SERVICE BULLETIN ML 0008

Date : 05 August, 1999
Game : All Games
Subject : Possible Floating Logic Ground

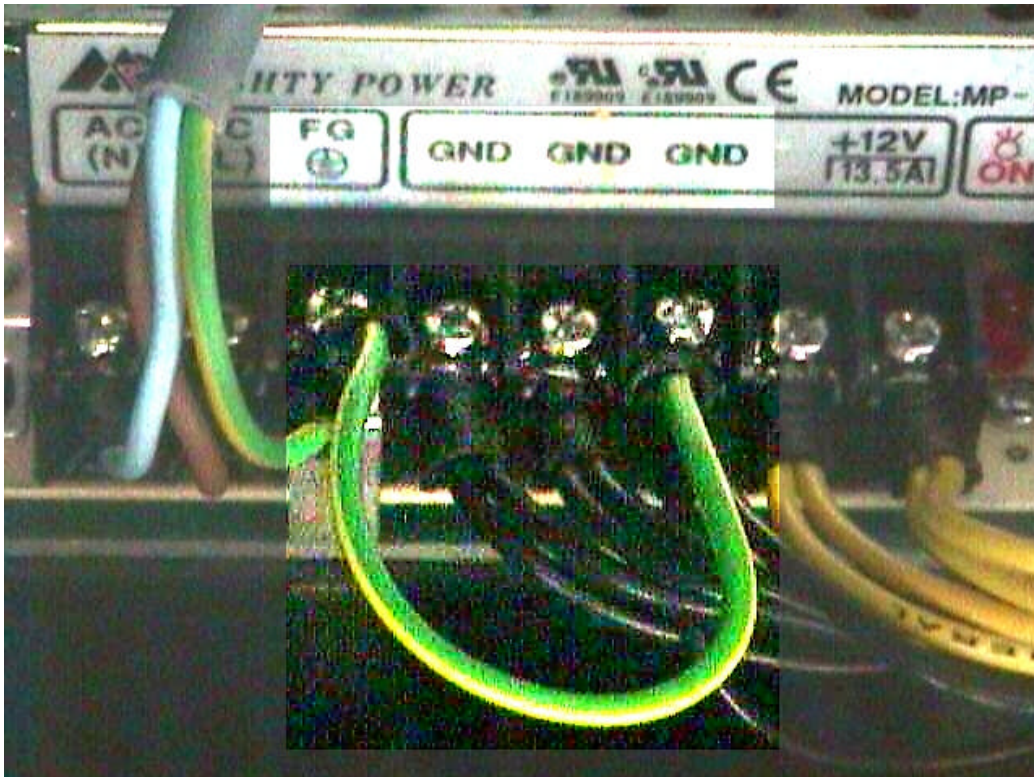
: It is possible that the Logic Ground from the Switch Mode Power Supply can have a floating voltage above the earth line. This can result in electric shocks to service personnel handling components powered by the Switch Mode Power Supply while the machine is On. It can also cause static related problems to the Logic Boards.

: To eliminate this possibility, the Earth (FG) and Logic Ground (GND) on the Switch Mode Power Supply must be jumpered together. (See Photo) The Jumper is about 5cm of 0.75mm with screw post connectors at each end. This part can be made available at your closest LAI Games Distributor.
